**ART AND ARCHITECTURAL REVIEW BOARD (AARB)**

Name: New Biology Building

Number: 221-18473-000

## New Biology and Monarch Walk Updates

# Monarch Walk & Biology Compare

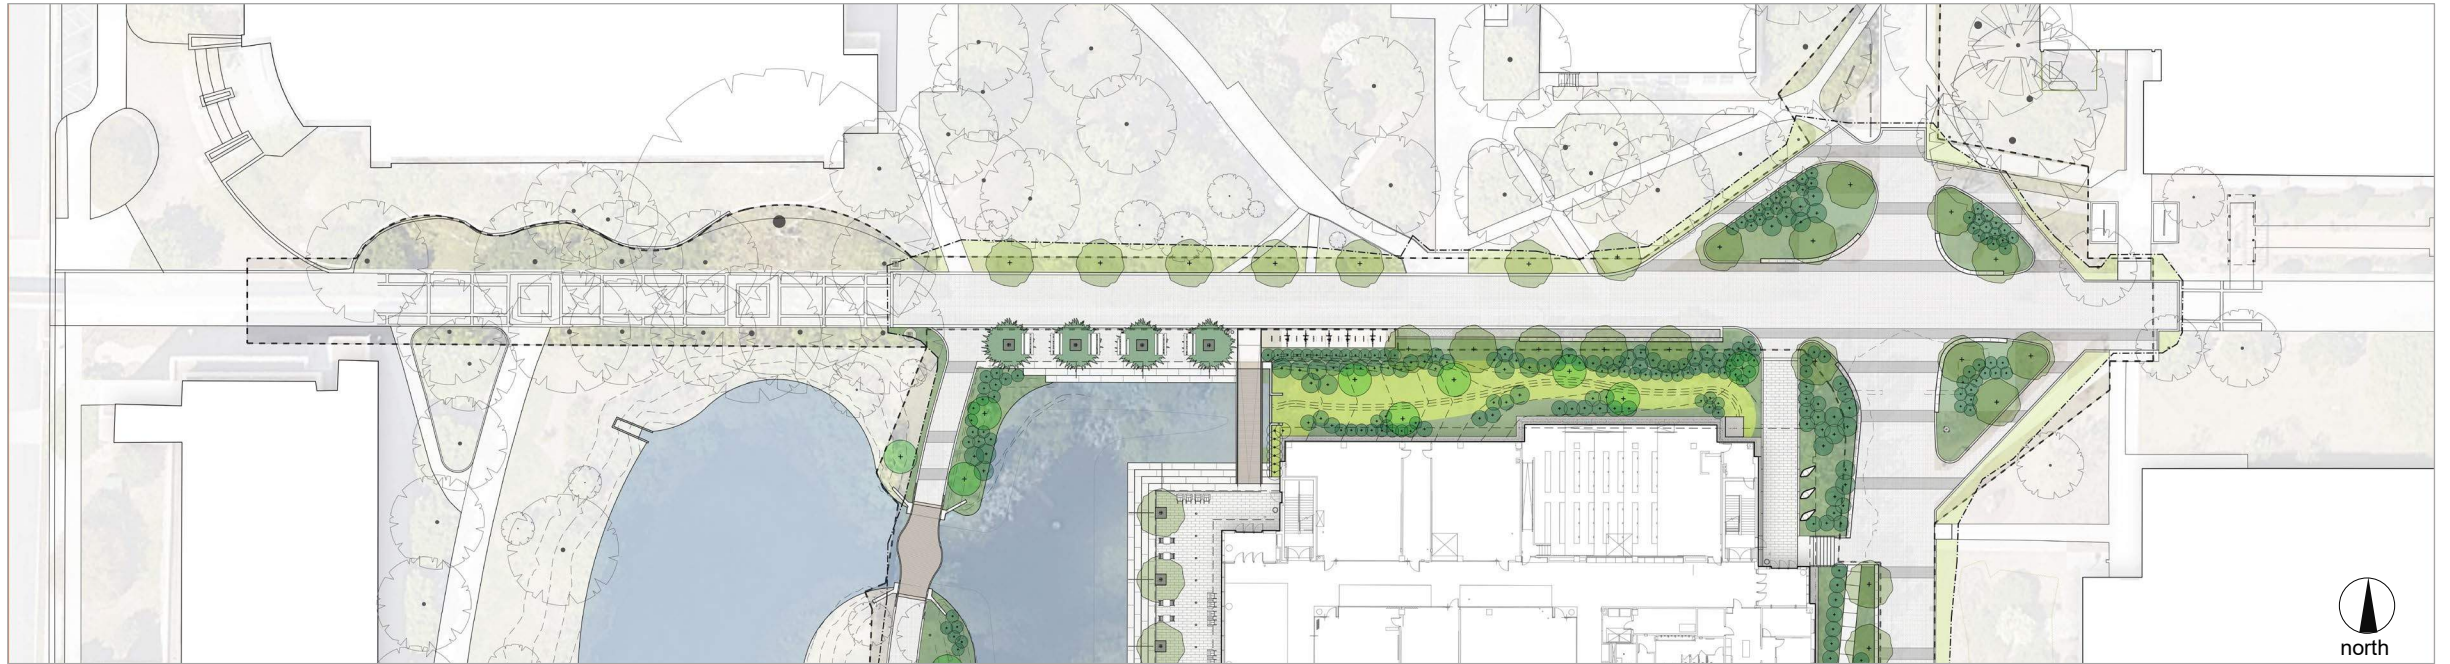
The New Biology project received AARB final approval in September 2022 and is under construction. This resubmission addresses site paving, furnishing and planting changes to two pedestrian walkways within the Biology site to conform to the broader campus planning goals of the Monarch Walk Design Study.

PROPOSED PLAN UPDATES

# Monarch Walk & Biology Compare

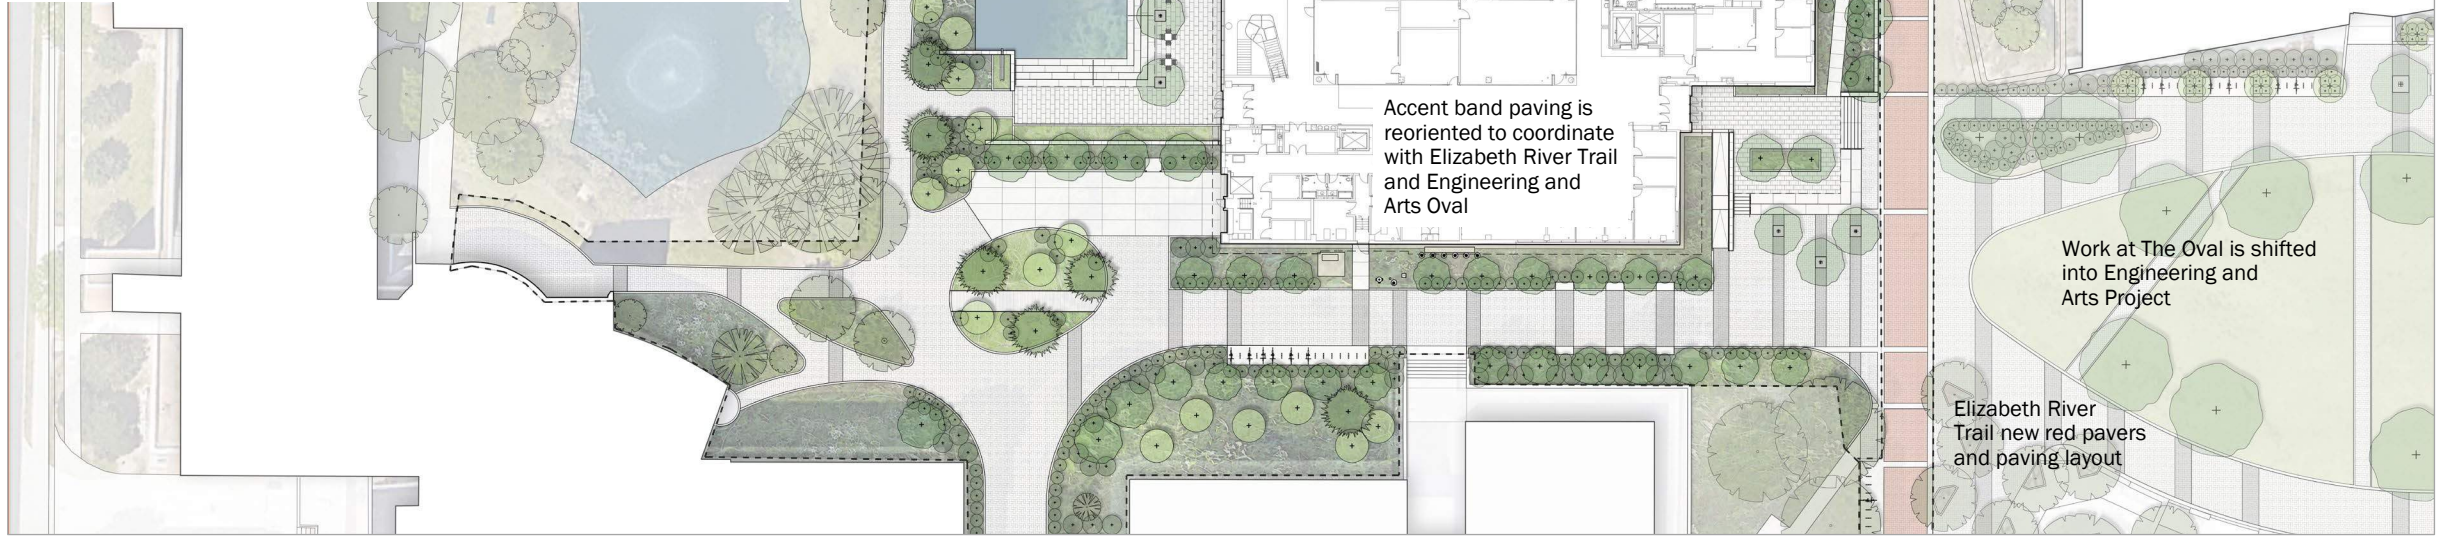
PROPOSED PLAN UPDATES

# Monarch Walk Planting Revisions

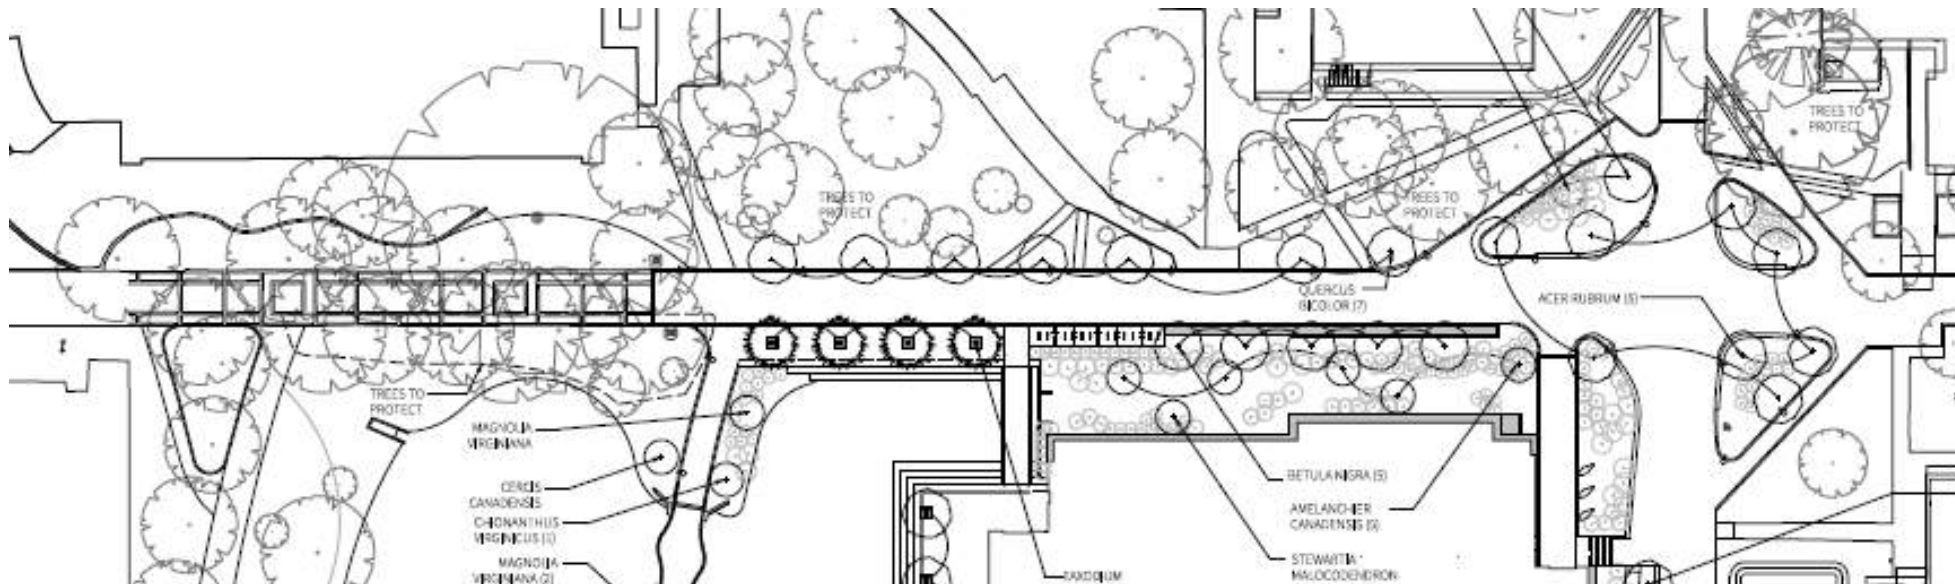
The proposed planting for the New Biology Project does not substantially change due to updates associated with the new work for Monarch Walk and The Elizabeth River Trail. Some new layout and positioning is required to coordinate with updated path geometry.
